<b>Docket Number:</b>	21-AFC-02
<b>Project Title:</b>	Willow Rock Energy Storage Center
<b>TN #:</b>	259675
<b>Document Title:</b>	Willow Rock Data Request Set 3 Response
<b>Description:</b>	N/A
<b>Filer:</b>	Kathryn Stevens
<b>Organization:</b>	WSP USA Inc.
<b>Submitter Role:</b>	Applicant Consultant
<b>Submission Date:</b>	10/23/2024 4:55:23 PM
<b>Docketed Date:</b>	10/23/2024

**Willow Rock Energy Storage Center (21-AFC-02)**  
*Data Request Response Set 3*

**GEM A-CAES LLC**

TITLE  
**SURVEYED CHOLLA WITHIN PROJECT AREA VICINITY**

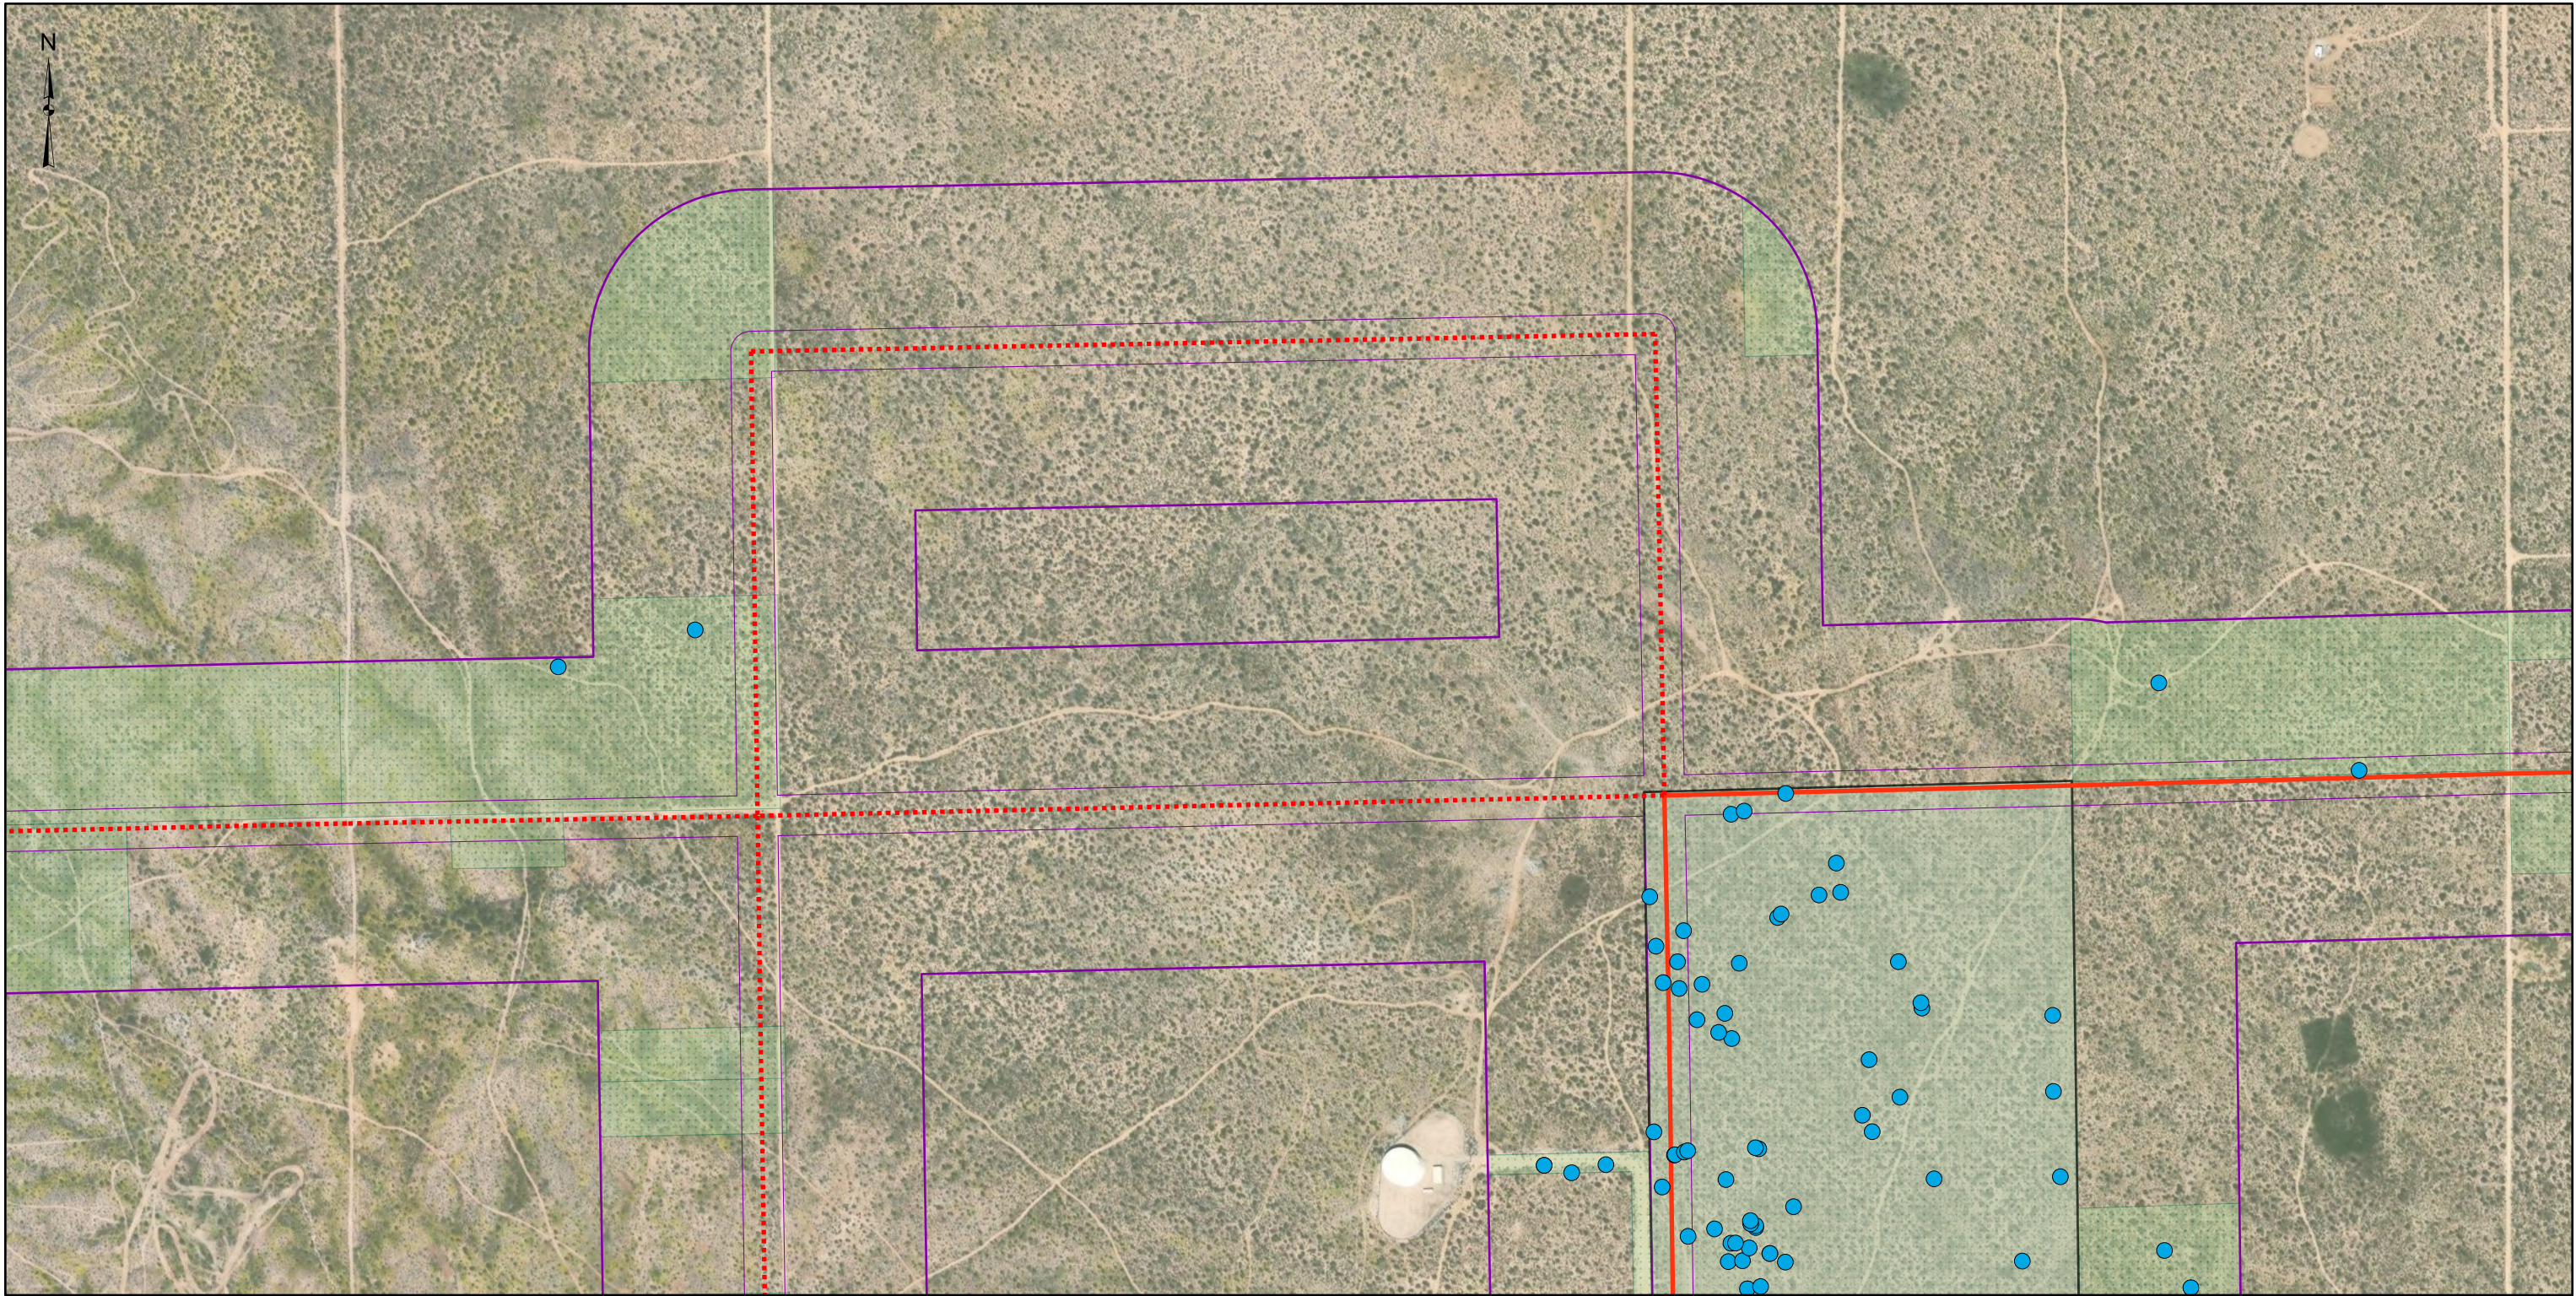
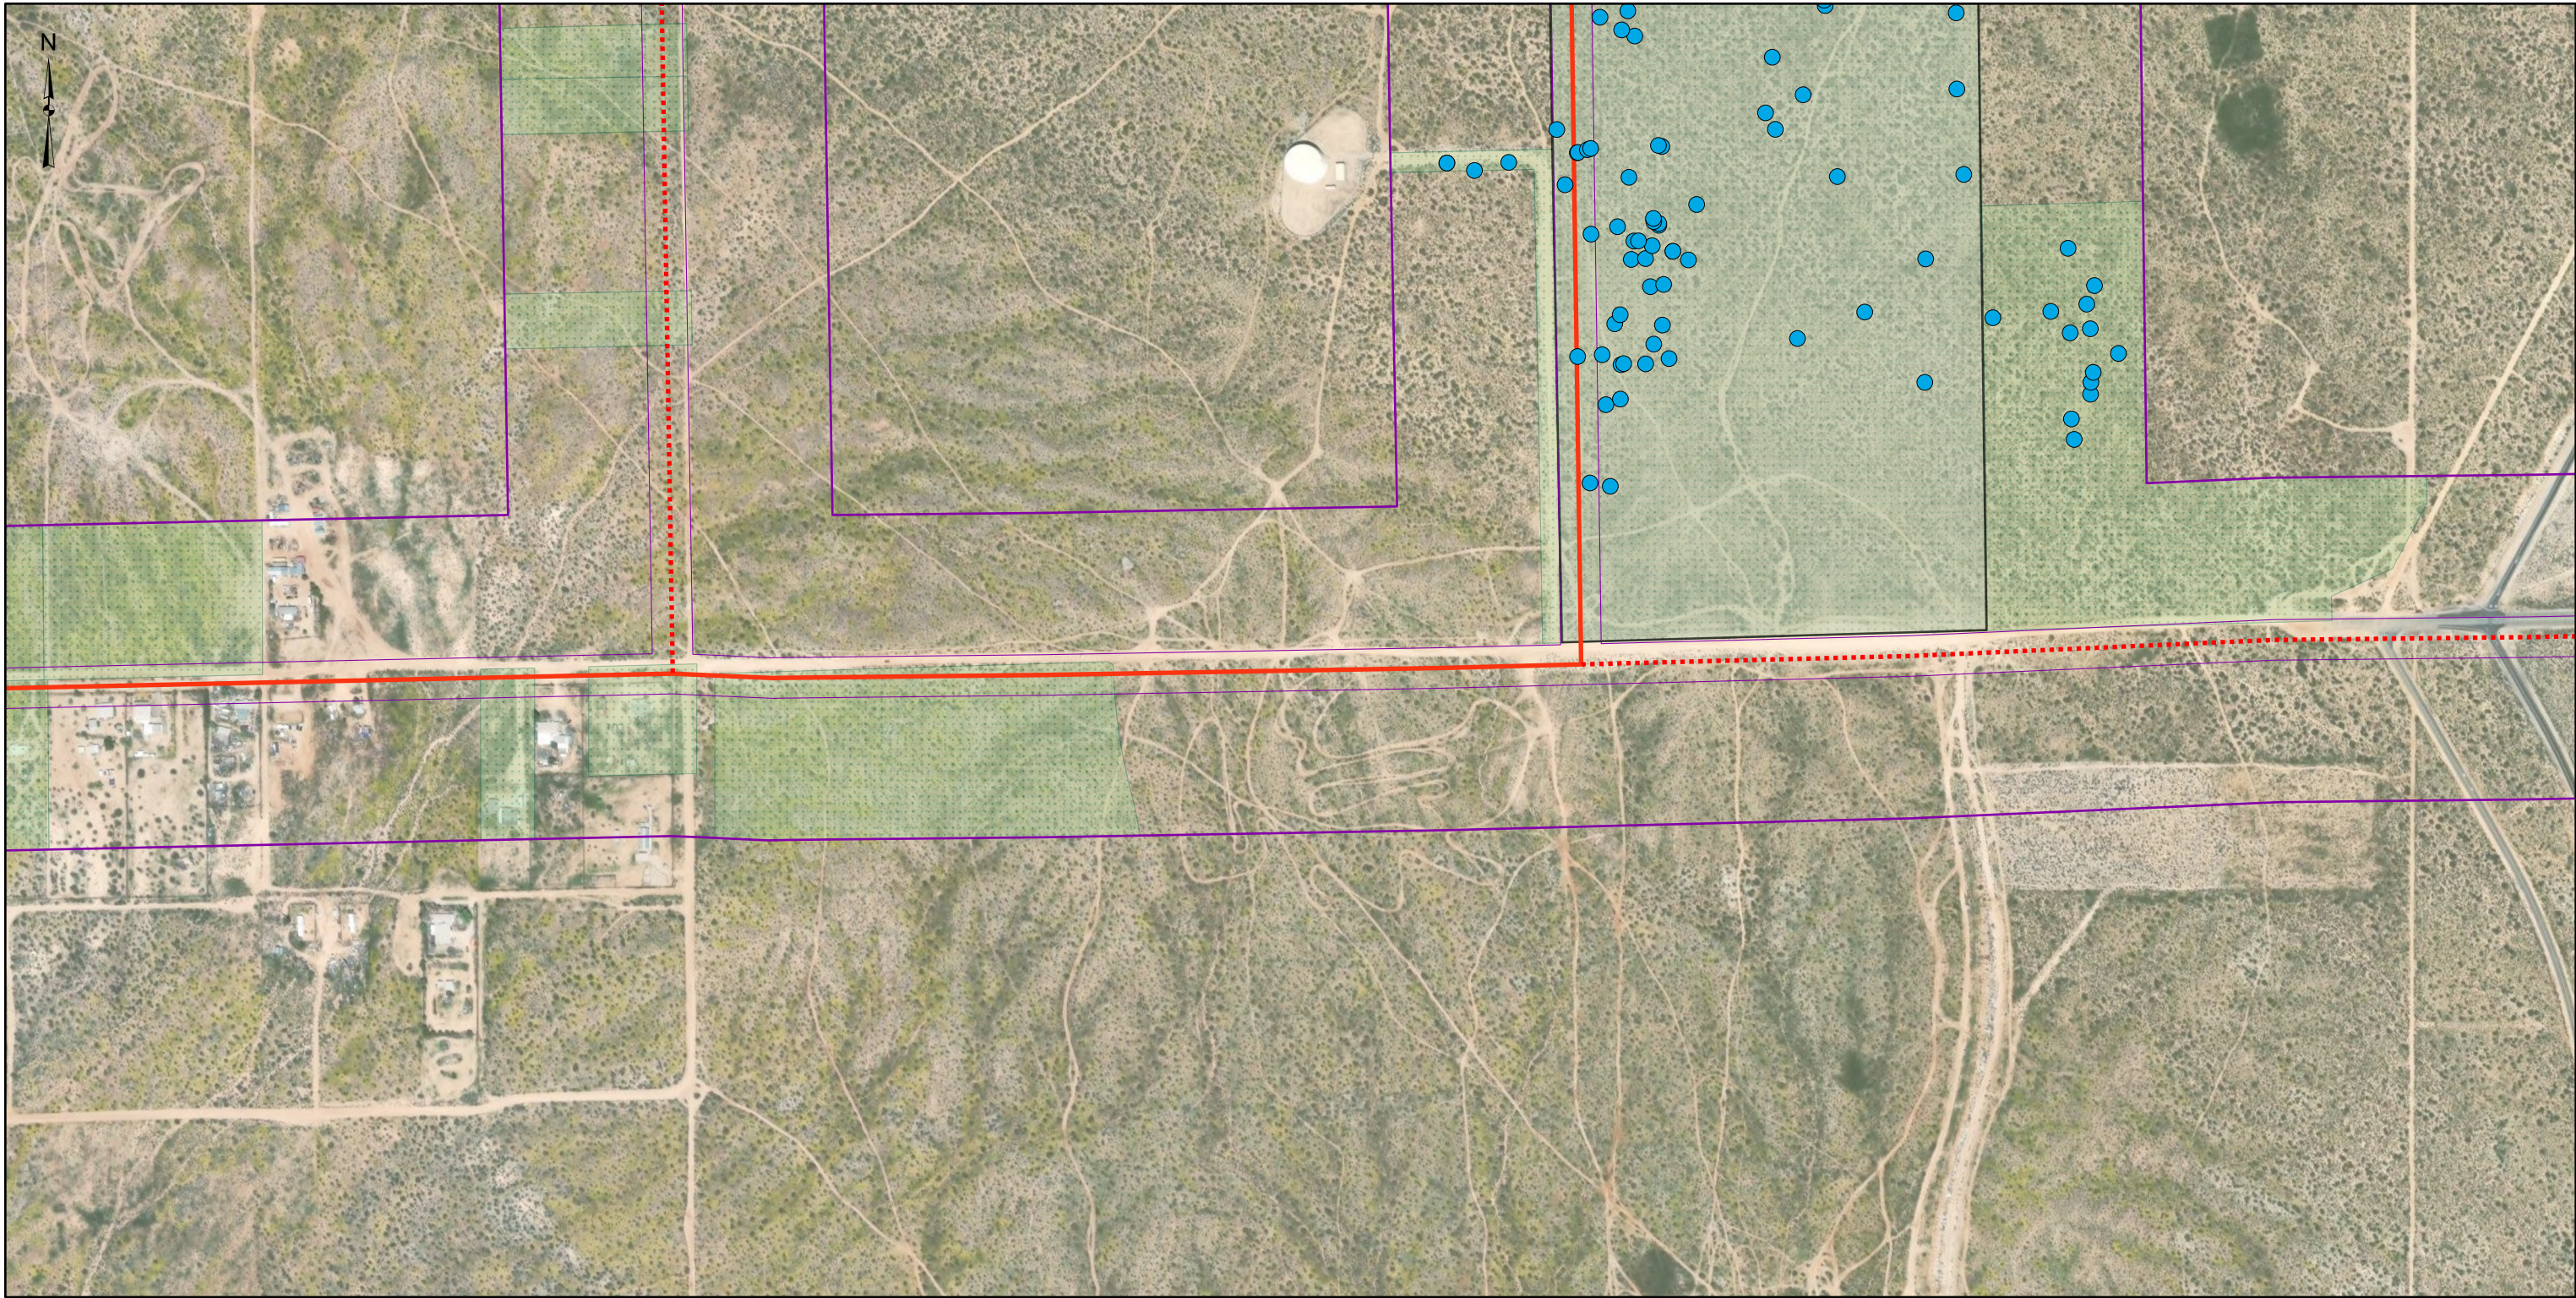
**DR44:** Please provide a map of the location(s) of silver cholla found within all areas of the project (e.g., project site, gen-tie, staging, parking, etc.) including (to the extent feasible) within a 500-foot buffer from the areas that will be impacted by the project.

**Response:** See **Attachment DR44-1** for a map of the locations of silver cholla observations found in all areas of the project within a 500-foot buffer.
